# PERMIT

SEWAGE DISPOSAL SYSTEM

REVISED  
Date: 8-23-91  
5435 Broadwater Lane  
Comments: 20096  
add 3x10 addition

Re: Foxview Manor - Lot 1  
5435 Broadwater lane

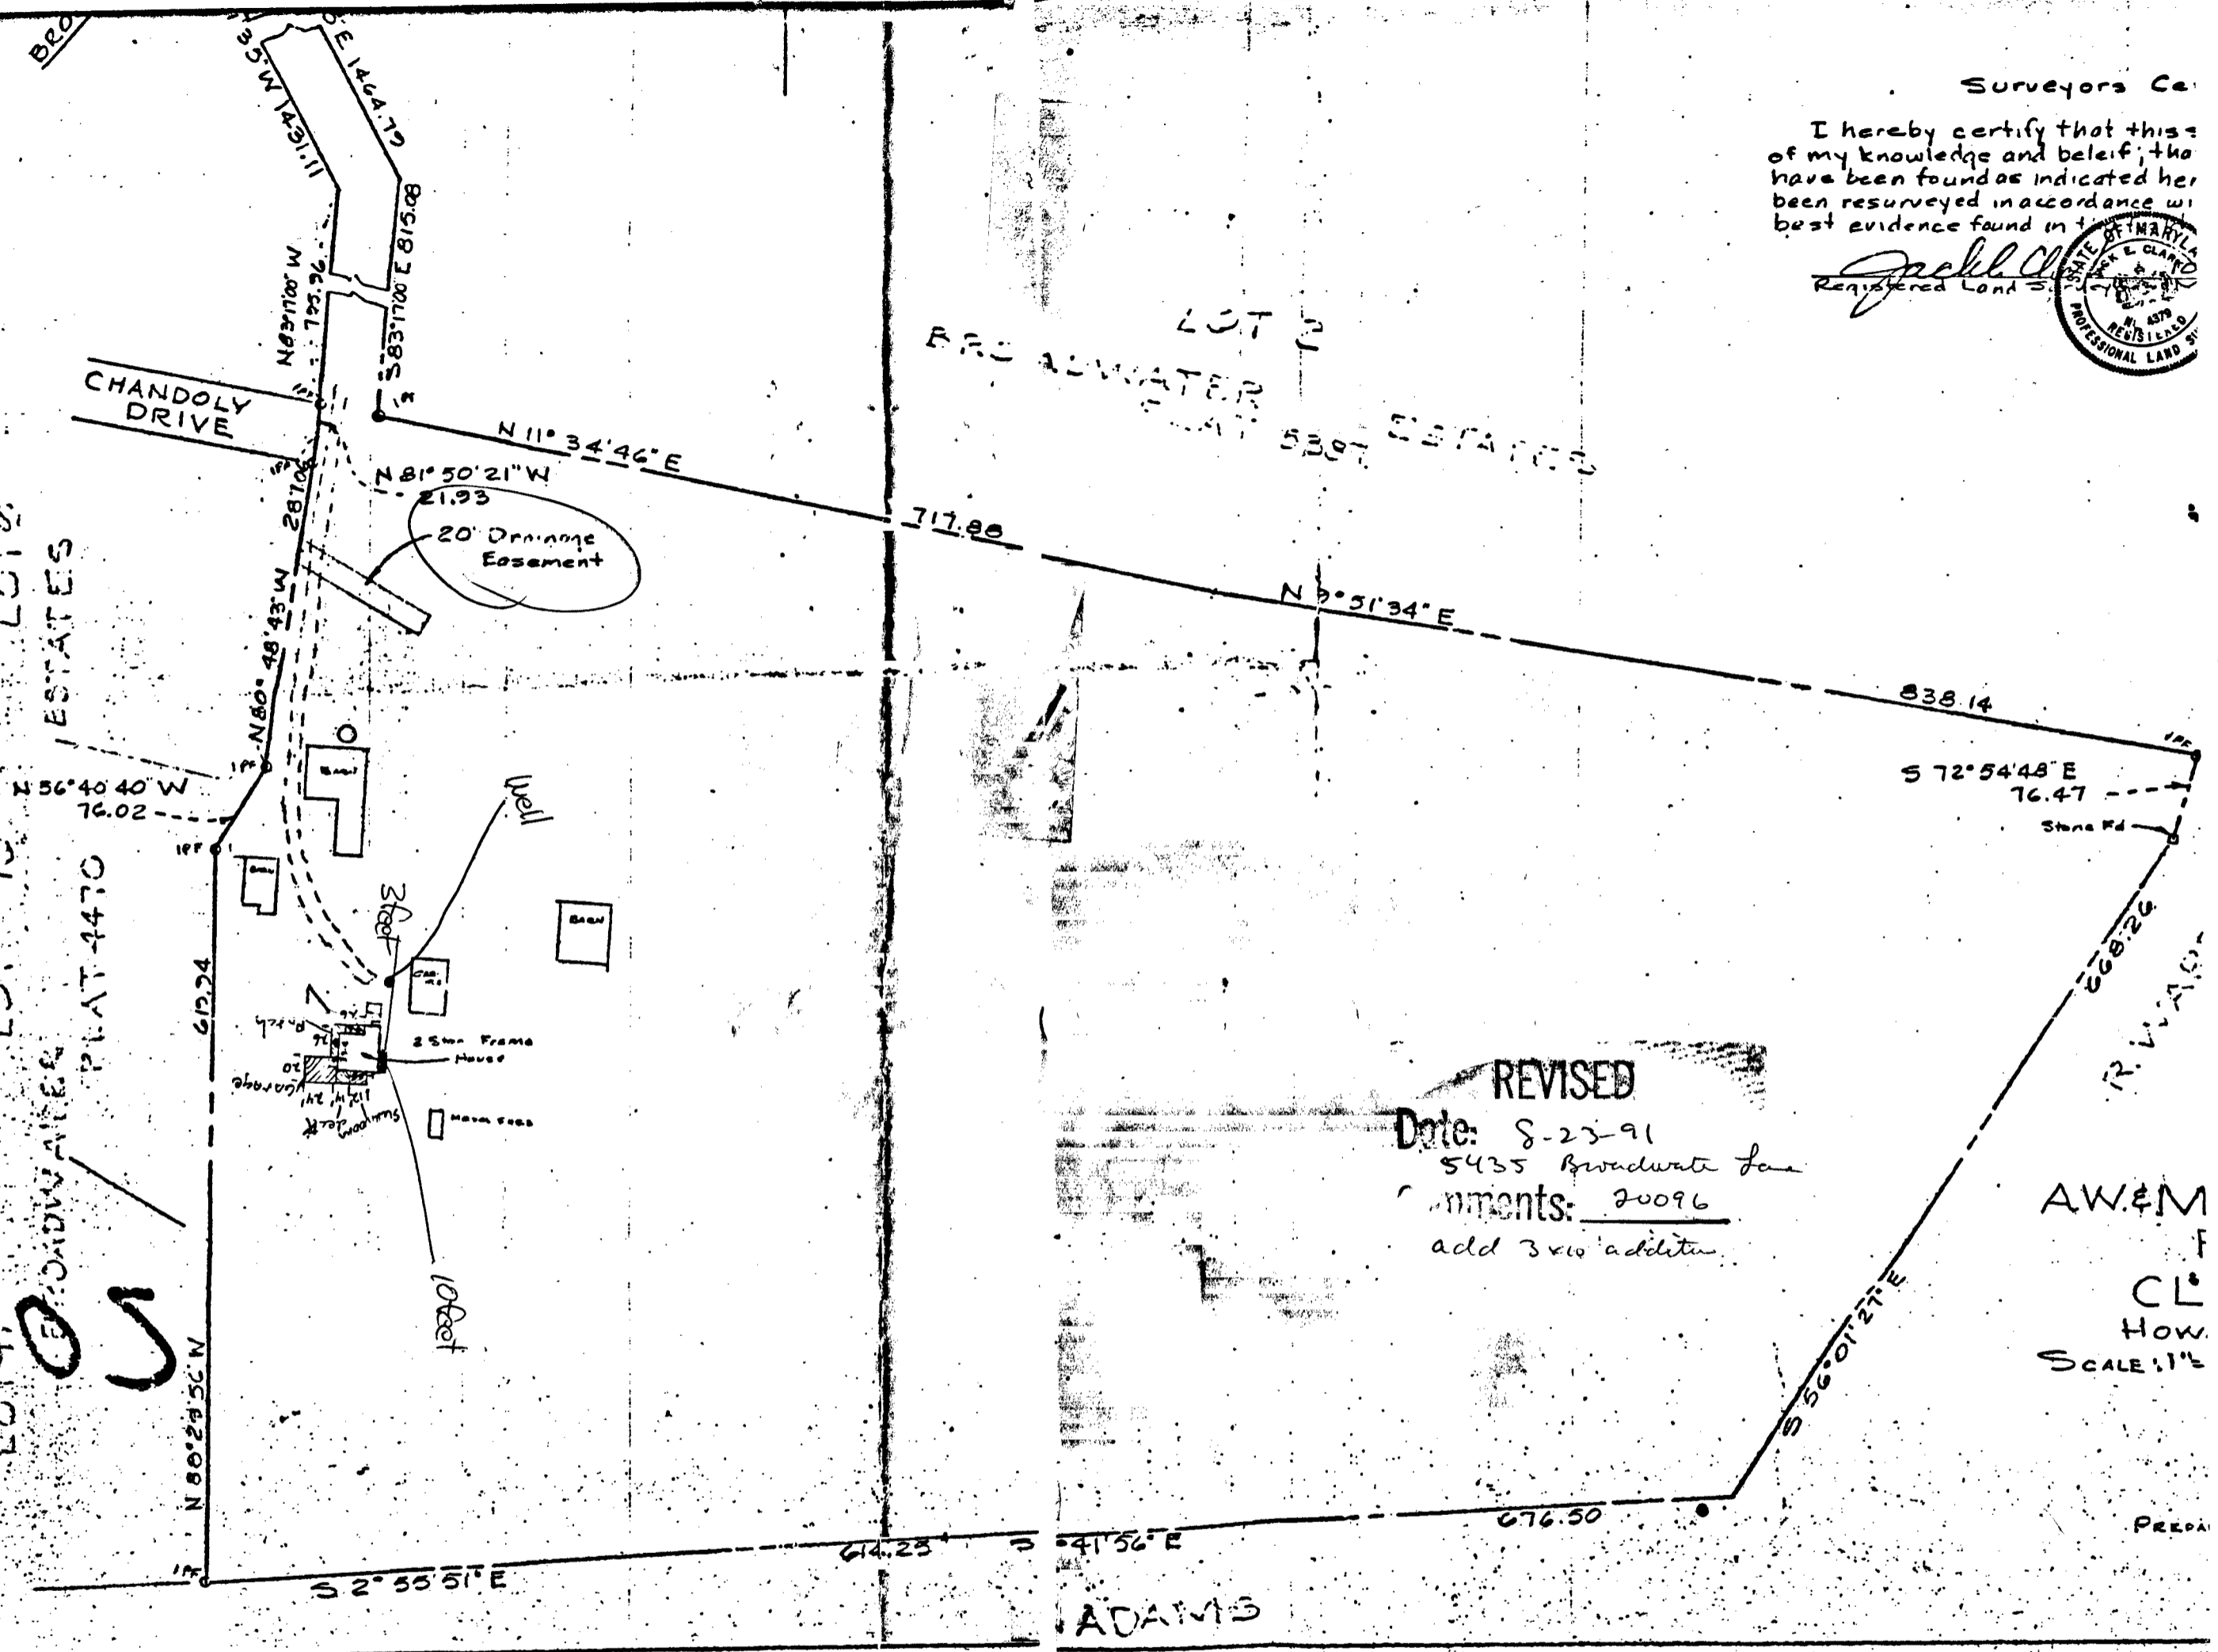
RECOMMENDS APPROVAL OF BRAMENDMENT & WELL STATUS REVIEWED LATER  
MR 8/28/91  
APPROVAL ON BRAMENDMENT

SEPTIC SYSTEM LOCATION UNKNOWN, BUT 3' ADDITION NOT LIKELY TO HAVE ANY IMPACT. WELL IS HAND-DUG, UNCOVERED, OPEN TO CONTAMINATION. RECOMMEND REVIEW OF WELL STATUS BEFORE RECOMMENDING APPROVAL ON BRAMENDMENT

REVISION APPROVED  
HOWARD COUNTY HEALTH DEPT.
